Access Report

Newcastle Grammar School
Park Campus Stage 1
Parkway Avenue
COOKS HILLS NSW

For: Newcastle Grammar School
Ref: LP_21100

State Significant Design Submission Documentation for The Newcastle Grammar School Park Campus Stage 1, located at Parkway Avenue Cooks Hill, has been reviewed against current accessibility legislation.

Figure 2 | Overall Site Plan

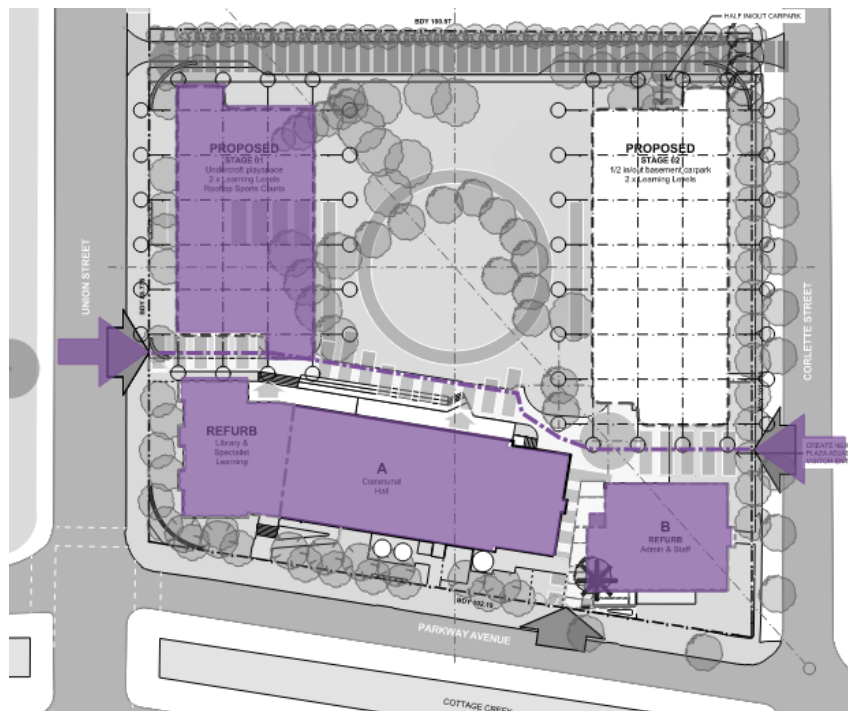
- from the allotment boundary at the pedestrian entrance along Union Street to the building entrance.
- from the allotment boundary at the pedestrian entrance along Corlette Street to the building entrance.
- between associated buildings with the site.

On-grade access will be available from both Union and Corlette Streets. New entrances will be provided from each street through the provision of a central plaza / circulation area.

A series of accessible pedestrian links are shown provided to facilitate access between buildings within the site.
